ANNEXURE E15: COMMENT FROM THE LOCAL AUTHORITY

RE: DBAR: THE DECOMMISSIONING OF AN AQUACULTURE FACILITY AND REDEVELOPMENT OF A PORTION OF FARM 1259, MALMESBURY RD AT PATERNOSTER

ANNEXURE E16: CONFIRMATION OF ALL SERVICES (WATER, ELECTRICITY, SEWAGE, SOLID WASTE MANAGEMENT)

PROPOSED MIXED-USE DEVELOPMENT ON ERVEN 1605-1610, 1613, 1751-1753 & FARM 1259, PATERNOSTER: CAPACITY ANALYSIS OF THE BULK WATER AND SEWER SERVICES

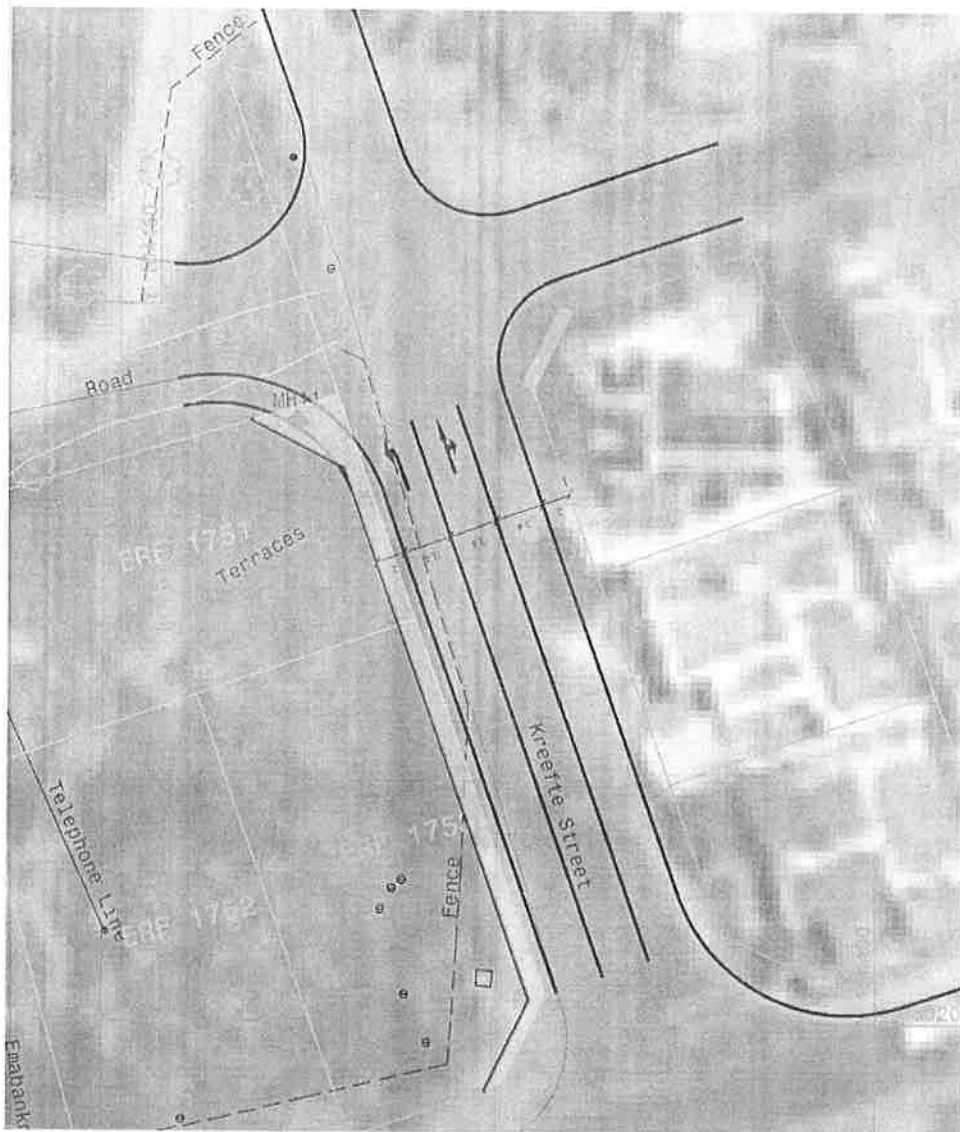
Application has been made for the rezoning of the Remainder of Farm 1259, Paternoster. The application has been held in abeyance until a solution can be found for road access to the said property as well as erf 2063, Paternoster ("the properties"). A discussion with officials from the Saldanha Bay Municipality took place on 12 May 2023 at which time options to gain access to the properties were discussed. It was proposed that an additional lane be created in Kreefte Ave.

Ek het met Jeremy gesels – hy is in beginsel aan boord met ons voorstel soos hier onder getoon. Die voorstel op die oomblik is om die verwagte probleme aan te spreek deur dit so eenvoudig as moontlik te hou. Die punte wat hy genoem het was 1) dat hy net sal wil sien wat ons met die stormwater van die publieke pad gaan doen, maar dit sal ons aanspreek in ons ontwerp, en 2) dat ons net sal moet sekermaak oor daardie bestaande erwe aan die oorkant se opritte en hoe almal inpas by die voorstel. Op daardie noot, ons sal 'n opmeting van Kreefte St moet laat doen vir ontwerpdoeleindes – het ons 'n opmeter op die projekspan wie ons kan kontak daarvoor, of kry ons kwotasies?

The implementation of the above will entail the consolidation of erven 1751, 1752 and 1753 and the subsequent subdivision thereof to make provision for the extra lane in Kreefte Ave as well as the consolidation of erven 1605, 1606, 1607, 1608, 1609 and 1610 and the rezoning thereof to provide for parking (hereafter jointly referred to as the "consolidation and subdivision"). The process could take two to three years. As a result the rezoning of Remainder Farm 1259 will also have to stand over.
